Minor Amendment to Site Plan - EPC for adjustments in response to soil and drainage conditions, accessibility requirements, and reviewer comments at building permit.

RE: Andalucía Senior Housing Site Plan and Related Applications

The purpose of this letter is to request approval of a Minor Amendment to the Overture at Andalucia Site Plan – EPC based on changed conditions and design changes necessitated during development of the building permit drawings due to platting, accessibility, and soil conditions. The subject site is legally described as Tract 4, Plat of North Andalucia at La Luz containing approximately 7.7 acres and is located at 5301 Antequera Road NW.

**Overture Andalusia Senior Housing
PROPOSED NAME OFSITE DEVELOPMENT PLAN**

SHEET NUMBER
AS-101

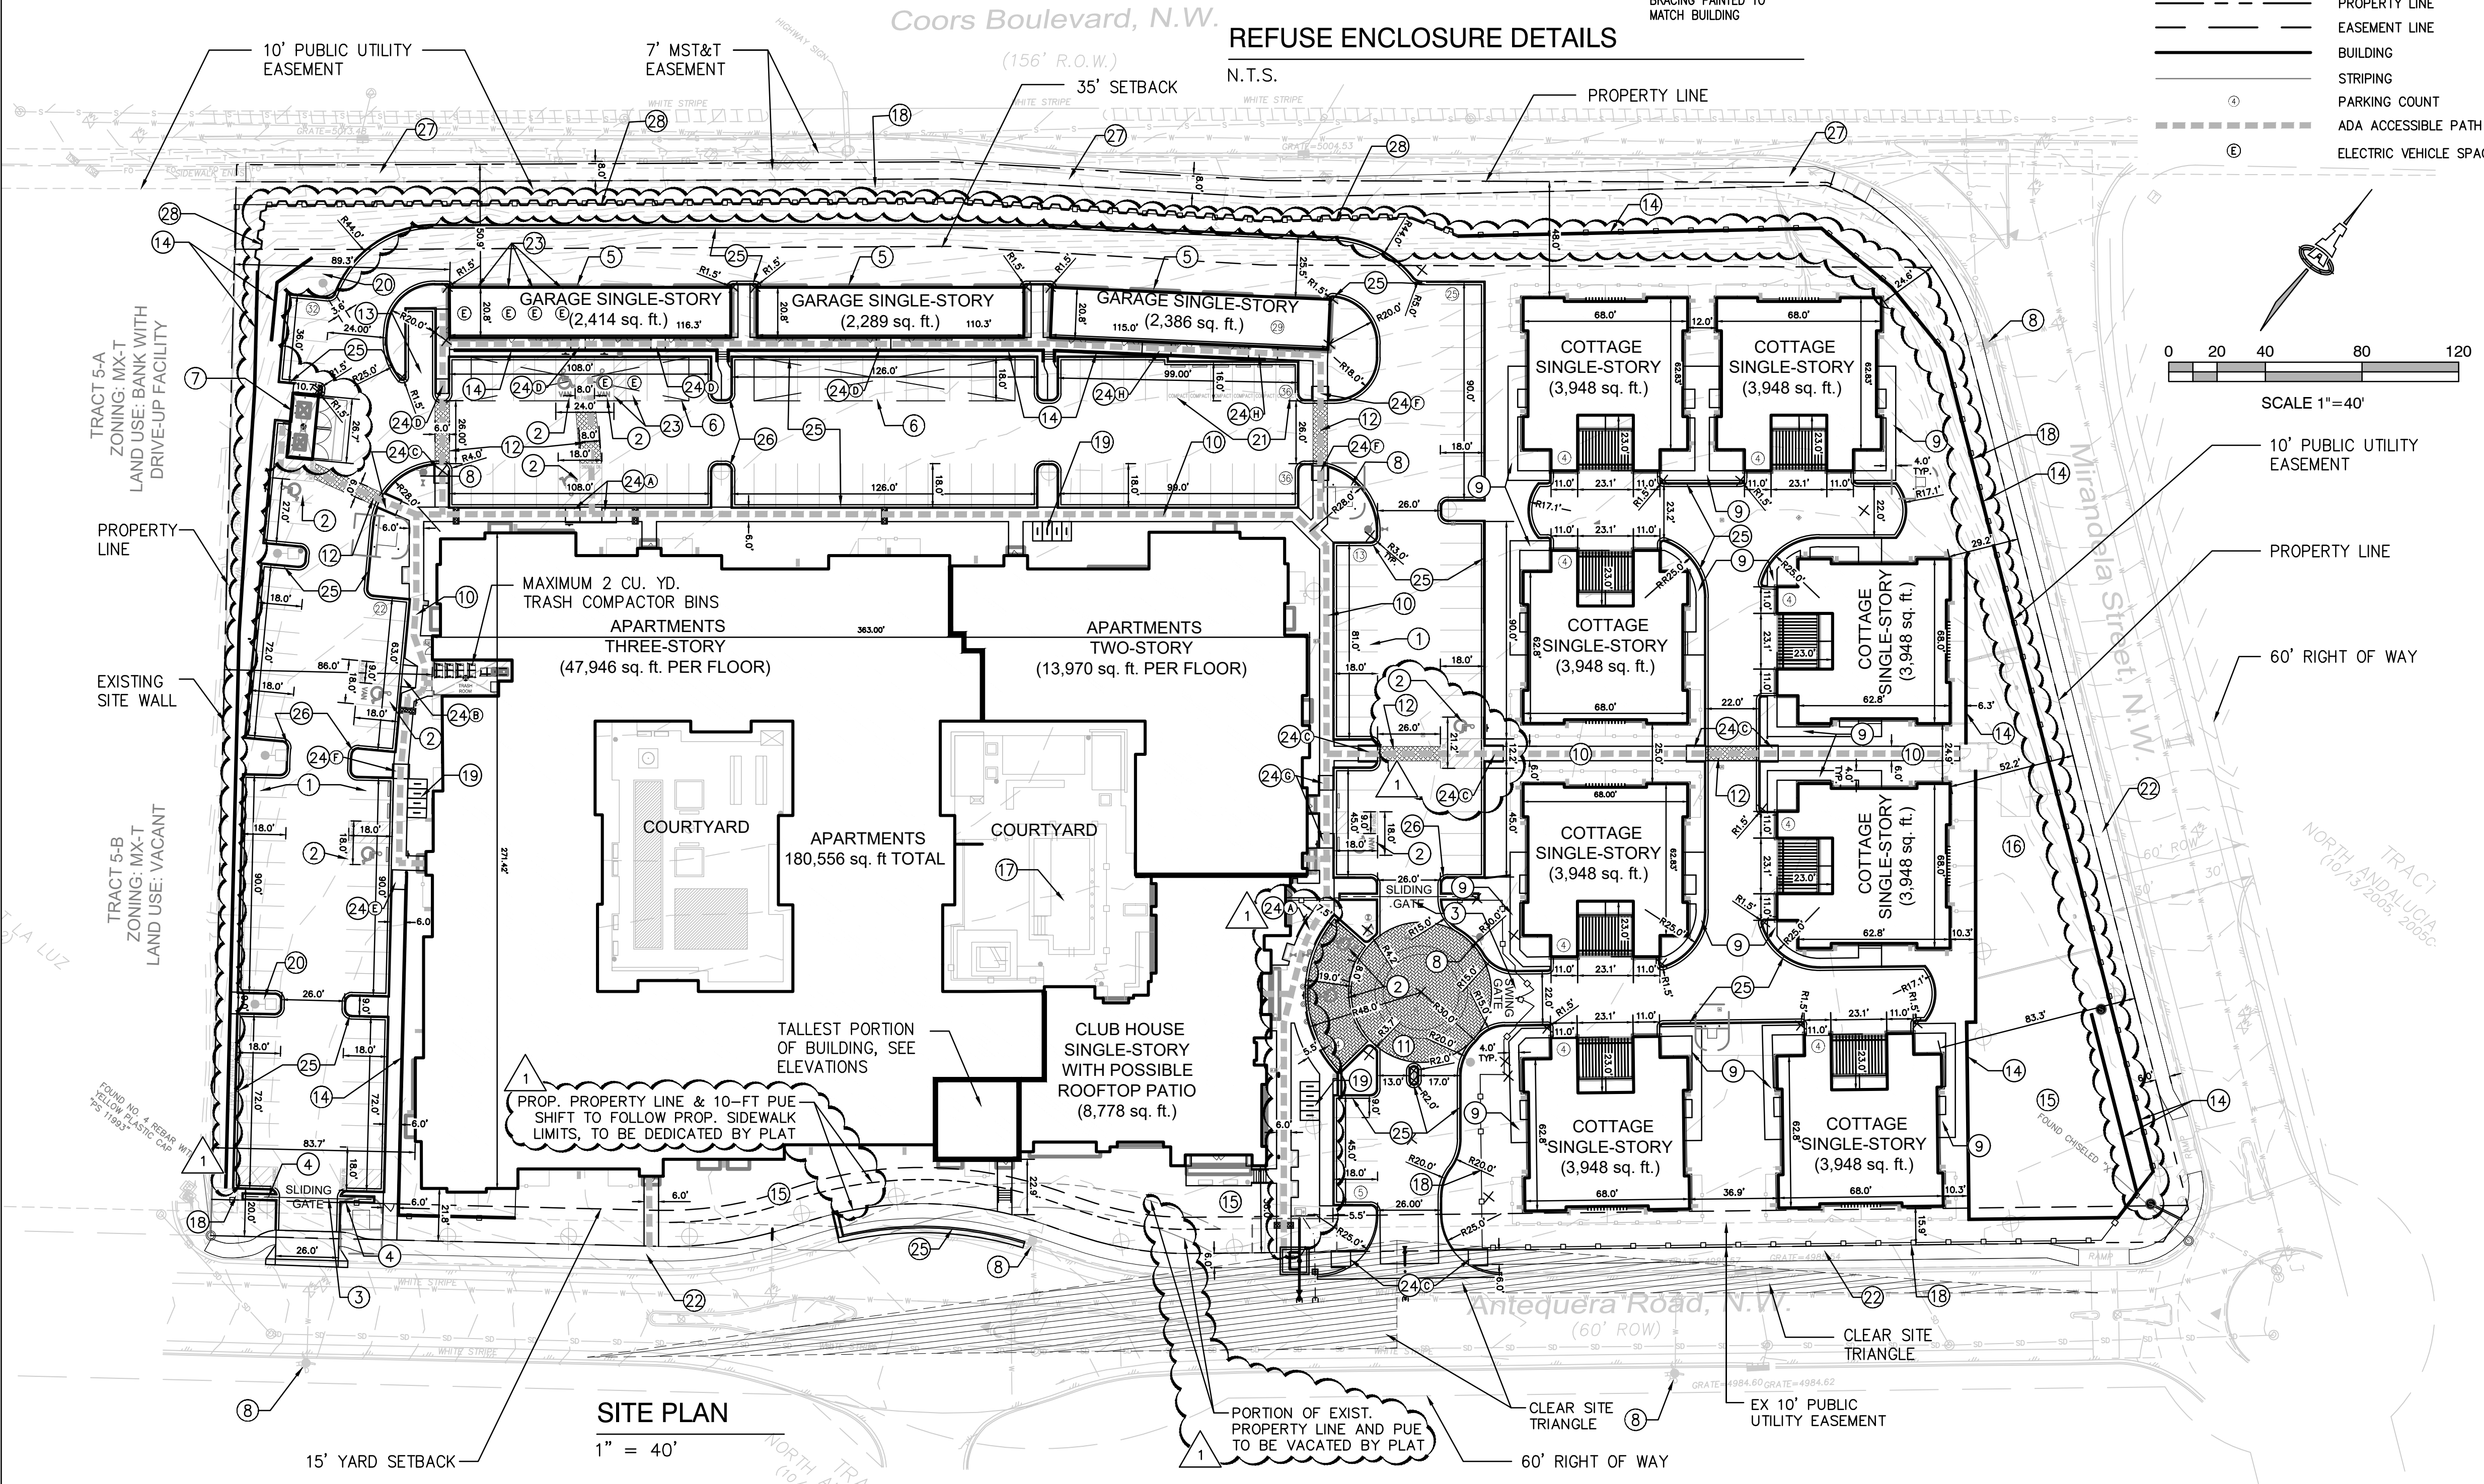
3. Modifications were required to the accessible walkway entering the site and additional accessible parking spaces have been added based on City ADA review of the project. ADA ramp details have also been slightly updated to meet current Transportation standards.

These changes are clouded and noted on the attached revised Site Plan, details, and elevation sheets. The Grading and Drainage plan was resubmitted and approved by Hydrology staff for the new retaining wall and updated site plan. Lastly, the Landscape Plan was updated to reflect minor adjustments to the landscape areas and tree placements to match the changes on the site plan.
